# BENT GRASS EAST COMMERCIAL FILING 3

### PRELIMINARY PLAN

PCD#: SP-20-010

PRELIMINARY PLAN

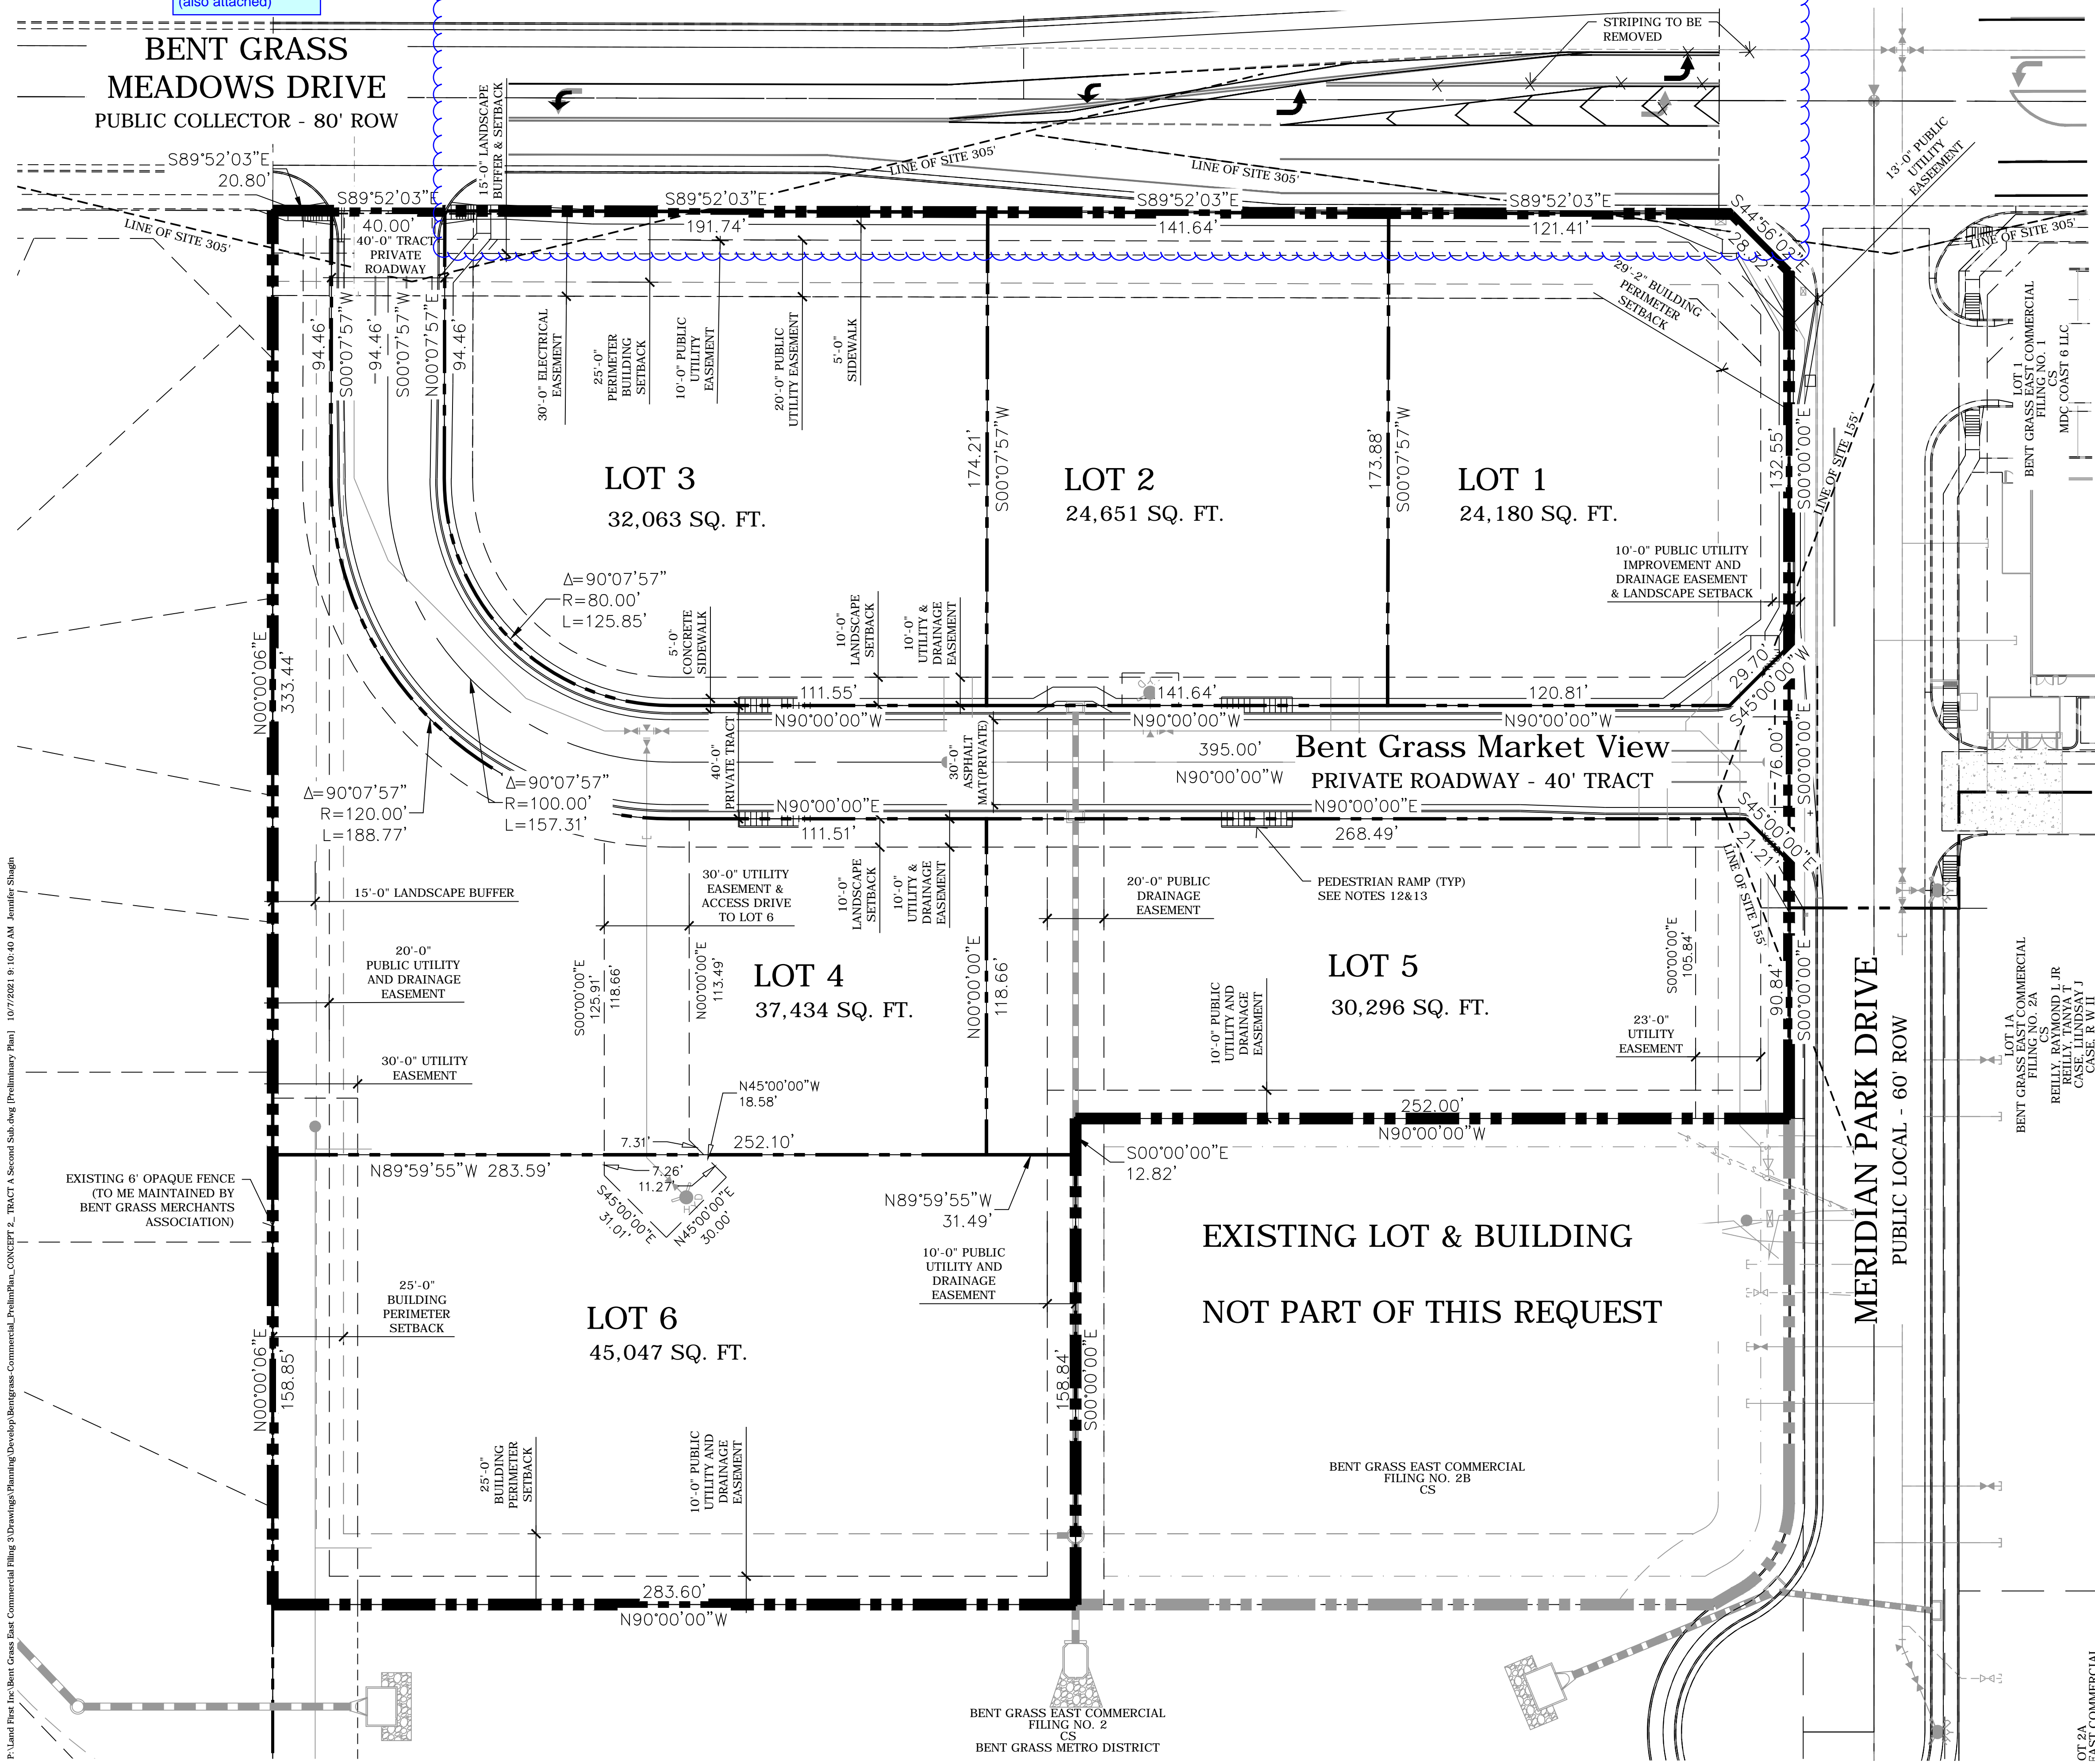
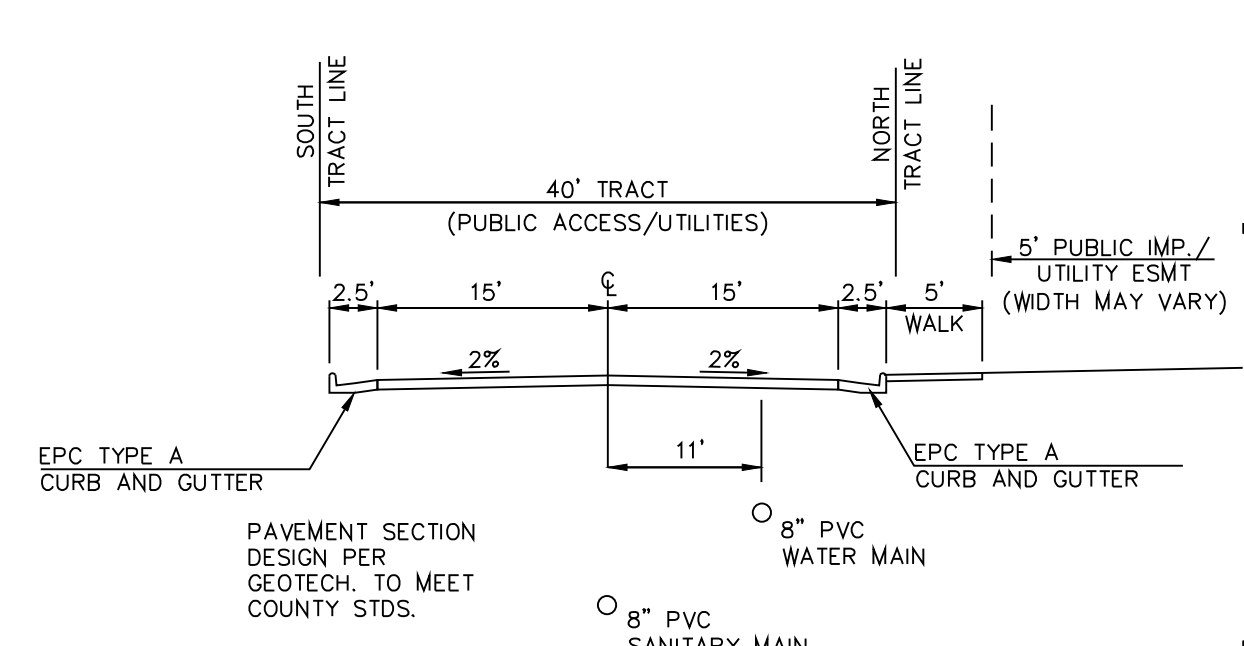
Please revise the stripping to reflect the TWLT variation exhibit that LSC sent via email and incorporate staff comments. Please see the exhibit that is uploaded to EDARP (also attached)

<b>BENT GRASS EAST COMMERCIAL FILING NO. 3</b>			
PRELIMINARY PLAN			
PRELIMINARY GRADING PLAN			
DESIGNED BY	PRA	SCALE	DATE 10-27-20
DRAWN BY	PRA	(H) 1" = 30'	SHEET 4 OF 7
CHECKED BY	(V) 1" = N/A	JOB NO.	2177.64

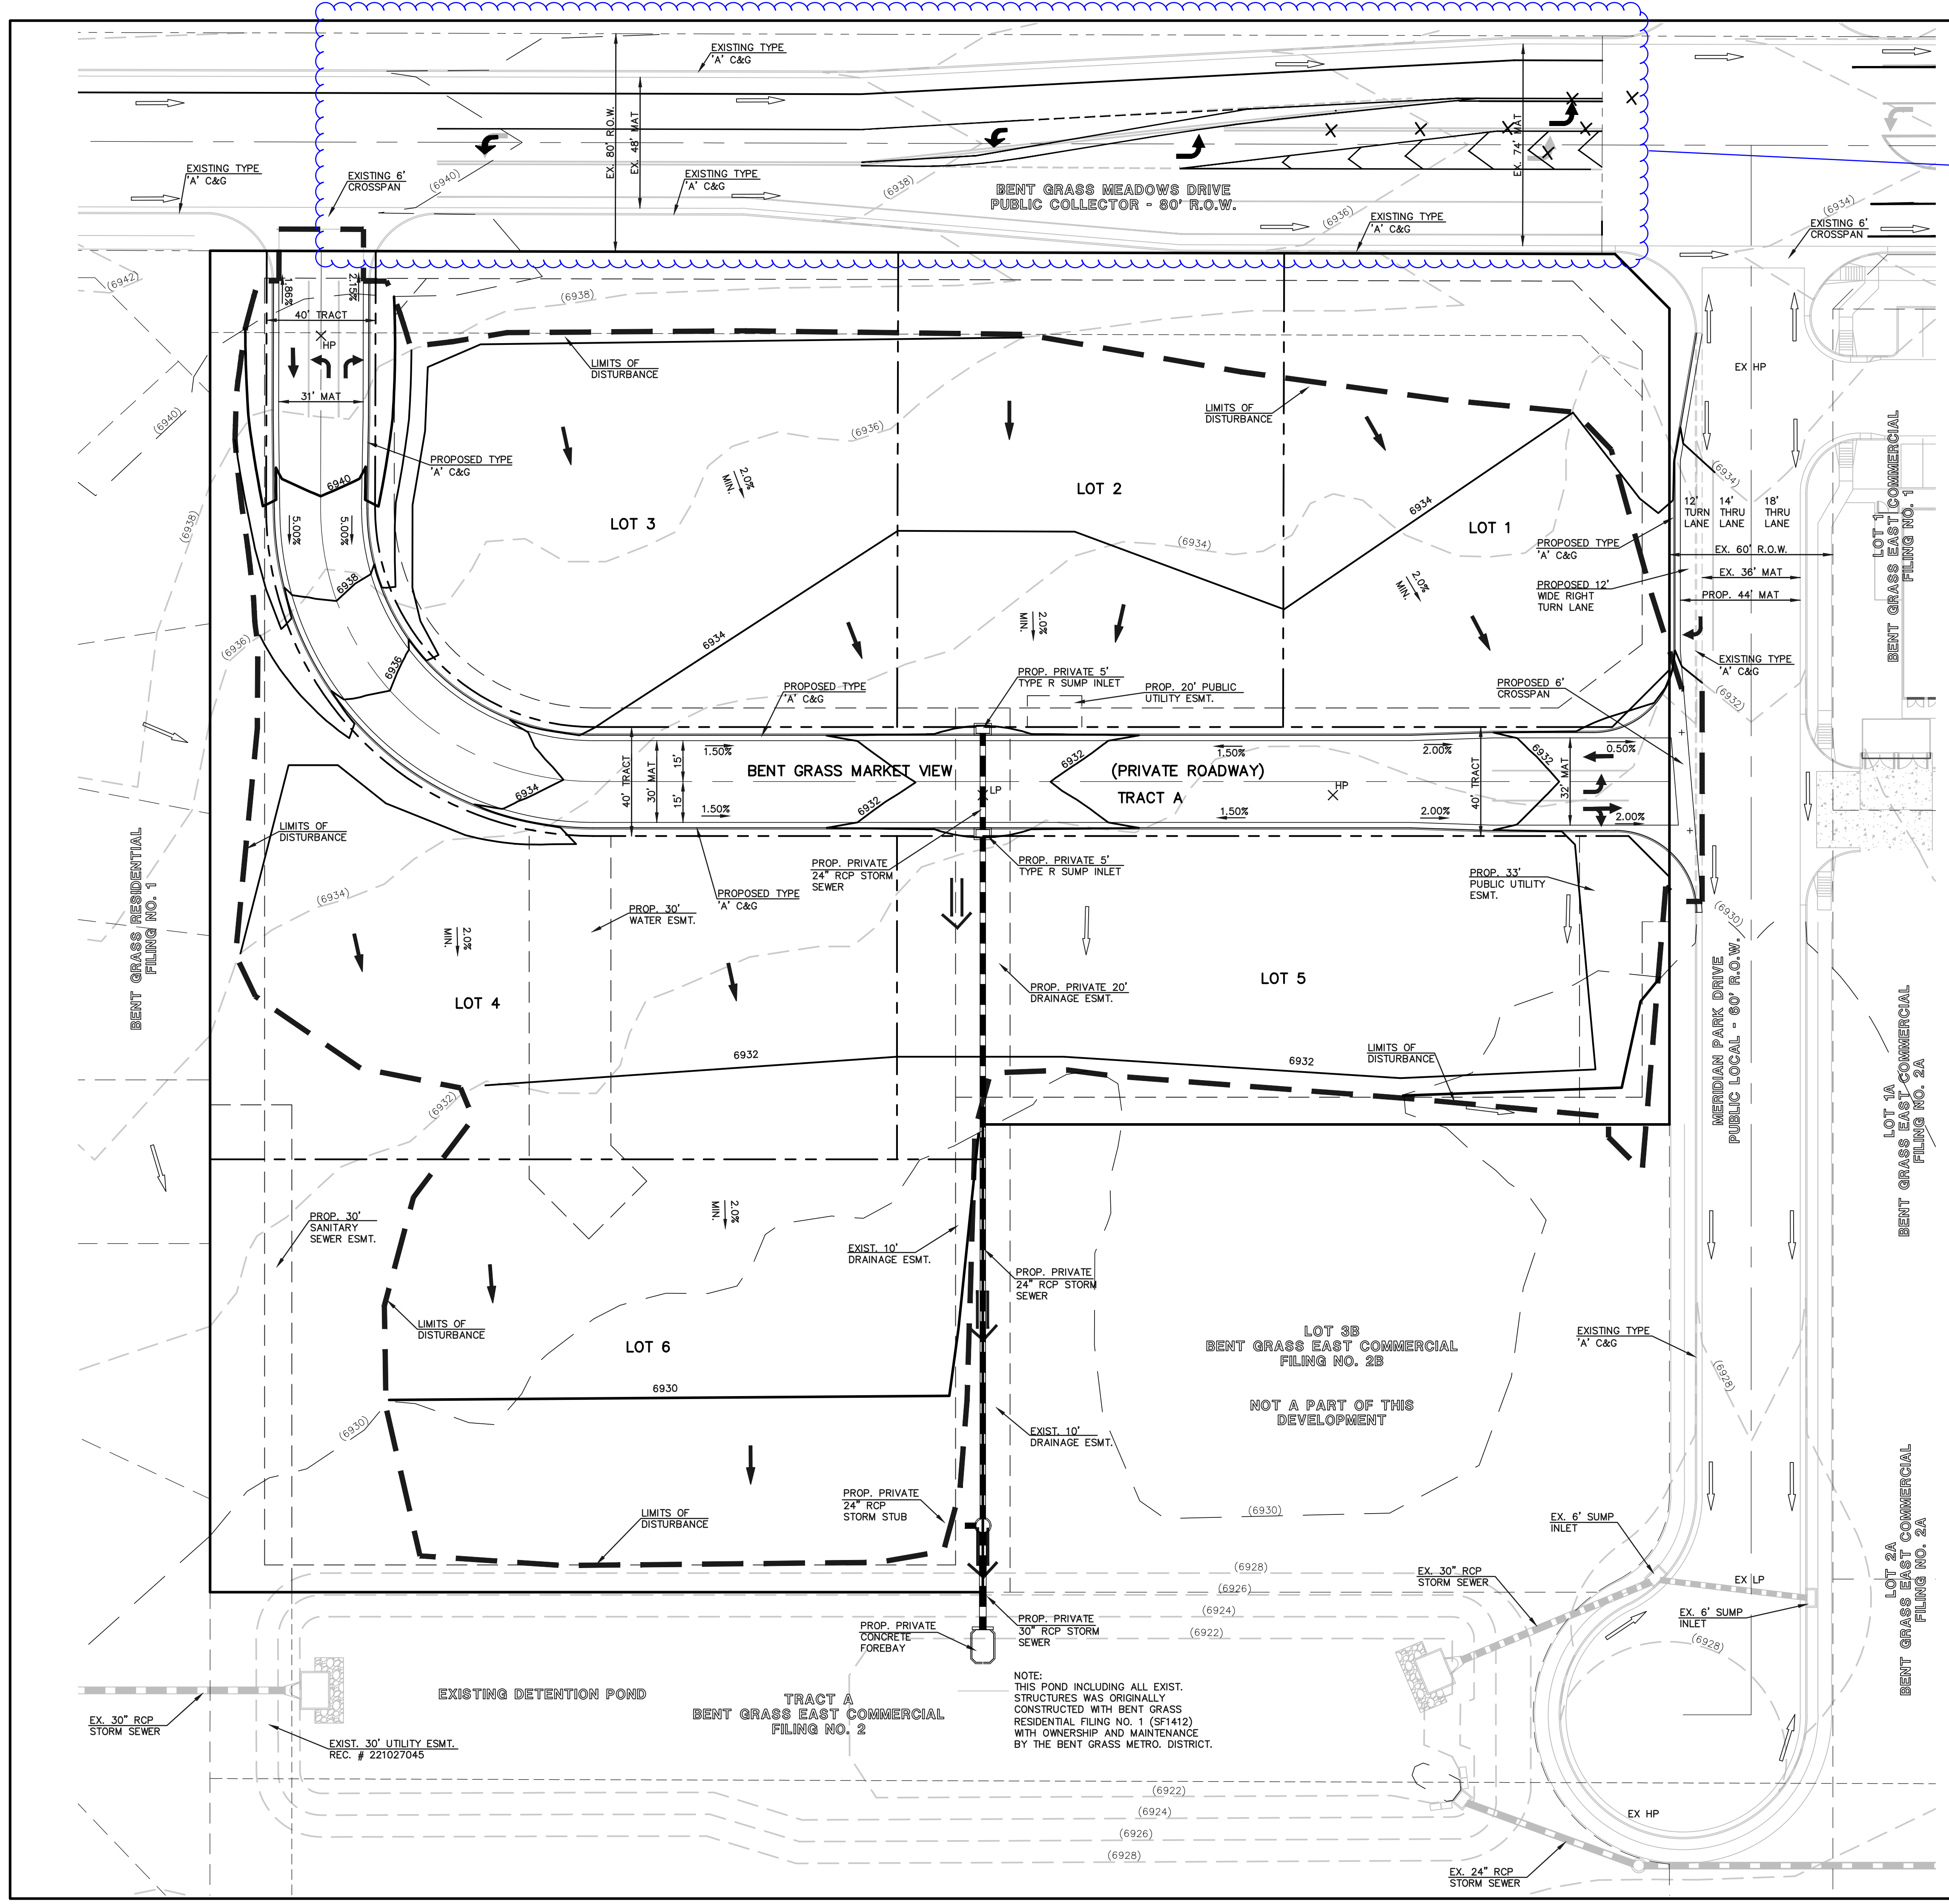
Please update per comment on the preliminary plan.
